**Commonwealth Edison**  
One First National Plaza, Chicago, Illinois  
Address Reply to: Post Office Box 767  
Chicago, Illinois 60690

November 6, 1981

Subject: Dresden Station Units 2 and 3  
Quad Cities Station Units 1 and 2  
Implementation of NUREG 0619  
Concerning BWR Feedwater and CRD  
Return Line Nozzle Cracking  
NRC Docket Nos. 50-237/249 and  
50-254/265

Figure 1. Feedwater Regulating Bypass Valve Control System

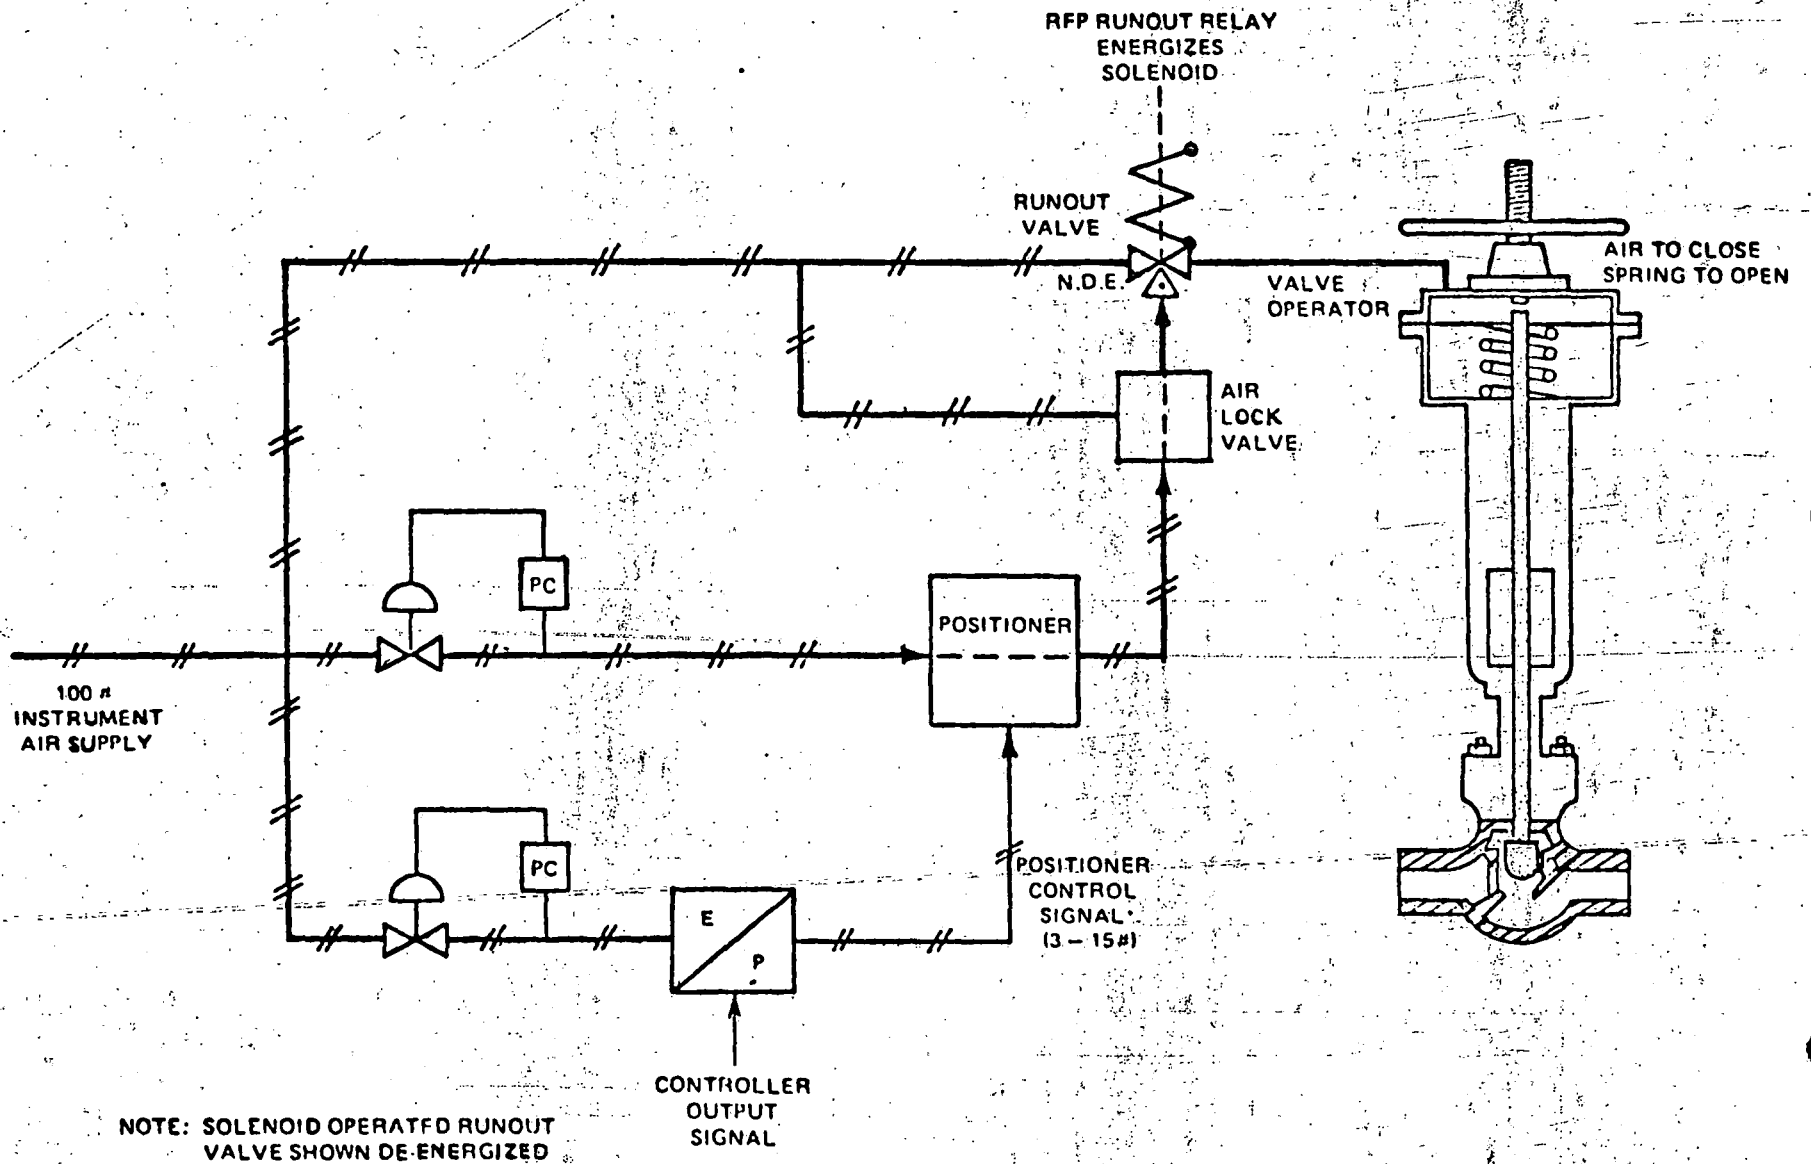
This arrangement of feedwater supply and low flow control system at Dresden Units 2 and 3 and Quad Cities 1 and 2 is similar to that used in the Monticello Nuclear Generating Plant, which has been previously demonstrated through instrumentation and analysis to provide acceptable nozzle thermal cycling in accordance with NUREG 0619 and NRC Generic Letter 81-11 crack growth requirements. Therefore, assuming that the system is operated in a like manner, similarly acceptable thermal cycling is expected. The only significant difference is that at Monticello, the original plug type valve was replaced by a drag valve in order to facilitate use of the automatic level control capability. The globe type valves in place in Dresden and Quad Cities may limit the ability to utilize the automatic control feature at very low power levels (<5%):

Our initial attempts to evaluate the severity of thermal cycling produced by low flow controller operation at Dresden and Quad Cities based on normally accessible plant data have proven inconclusive. Feedwater flow is normally measured through flow elements at the outlet of each of the reactor feedwater pumps, and summed to determine total feedwater flow. This measurement is too coarse to provide meaningful thermal cycling data in the feedwater nozzle region. Therefore, Commonwealth Edison is in the process of implementing a monitoring program, similar to that conducted at Monticello, to facilitate our evaluation of low flow controller thermal cycling. This program consists of:

1. Installation of thermocouples on the horizontal length of feedwater pipe in the vicinity of one reactor vessel nozzle.
2. Connecting a recorder to the input demand signal to the feedwater low flow control system.

Data from these two sources will be recorded during initial phases of one of the next convenient startup cycles at one of the four units once the equipment can be installed. The data will be interpreted in terms of amplitude and frequency of nozzle thermal cycling produced during low flow controller operation. The resulting thermal cycling will then be used as input to a fracture mechanics fatigue crack growth analysis to demonstrate whether or not the existing controllers at Dresden and Quad Cities meet the crack growth criteria of NUREG 0619/Generic Letter 81-11. In the event that the above analysis results do not meet the crack growth criteria, modifications will be implemented. These modifications may include change of startup operation procedure and bypass valve type.
